DEVELOPMENT APPLICATION ASSESSMENT REPORT

Application Number:	DA2024/1601		
Responsible Officer:	Jordan Howard		
Land to be developed (Address):	Lot 391 DP 838916, 12 A Rabaul Road NORTH CURL CURL NSW 2099		
Proposed Development:	Alterations and additions to a dwelling house		
Zoning:	Warringah LEP2011 - Land zoned R2 Low Density Residential		
Development Permissible:	Yes		
Existing Use Rights:	No		
Consent Authority:	Northern Beaches Council		
Land and Environment Court Action:	No		
Applicant:	Rapid Plans Pty Ltd		
Application Lodged:	26/11/2024		
Integrated Development:	No		
Designated Development:	No		
State Reporting Category:	Residential - Alterations and additions		
Notified:	04/12/2024 to 18/12/2024		
Advertised:	Not Advertised		
Submissions Received:	4		
Clause 4.6 Variation:	Nil		
Recommendation:	Approval		
Estimated Cost of Works:	\$ 462,715.00

Figure 1 - Annotated map of surrounding properties.

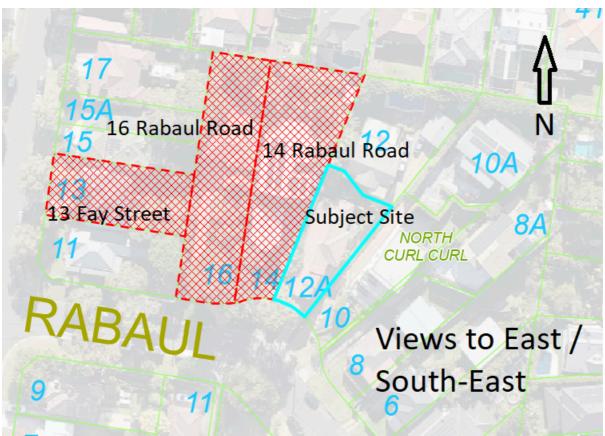
Figure 1 provides an annotated map of these properties to show their relationship to the subject site.

Figure 2 - Location and heights of height poles as surveyed by C&A Surveyors.

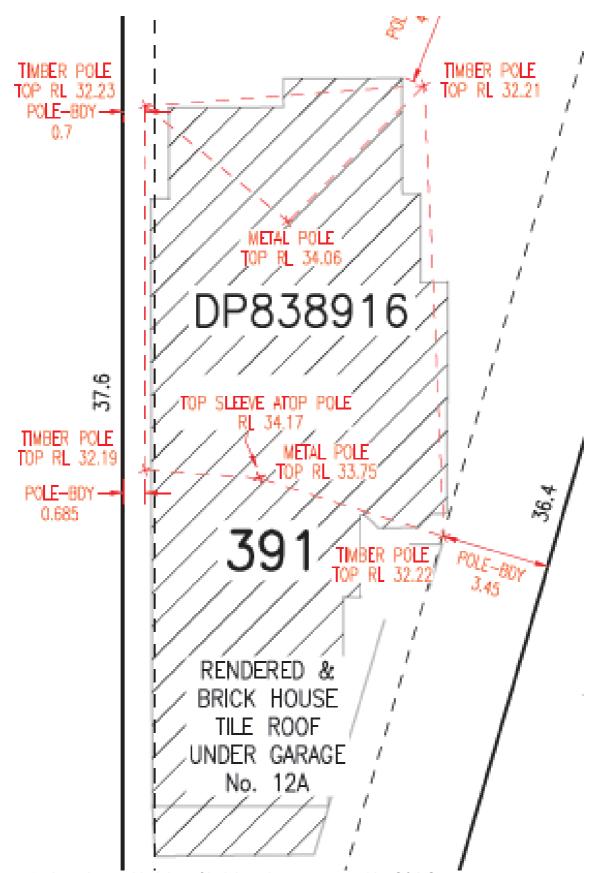
In order to enable an accurate view loss assessment, a request was made to the Applicant for height poles to be established at the subject site. These were installed at six (6) locations as shown in *Figure* 2, with the height and location confirmed by a Registered Surveyor.

Visits to surrounding properties were undertaken during the assessment process to ascertain the extent of view impacts and other concerns raised. *Figure 3* shows the view from 13 Fay Street. *Figure 4* to *Figure 5* shows the view from 16 Rabaul Road. *Figure 6* to *Figure 17* show the view from 14 Rabaul Road. Following these visits, issue was raised with the Applicant regarding the potential for view loss. As a result, the proposed development was amended to reduce the maximum RL of the roof ridge from 34.120m AHD to 33.676m AHD, a reduction of 444mm. Both the original and amended design will be discussed below. Note that images show height poles as surveyed to the original higher proposed building height.
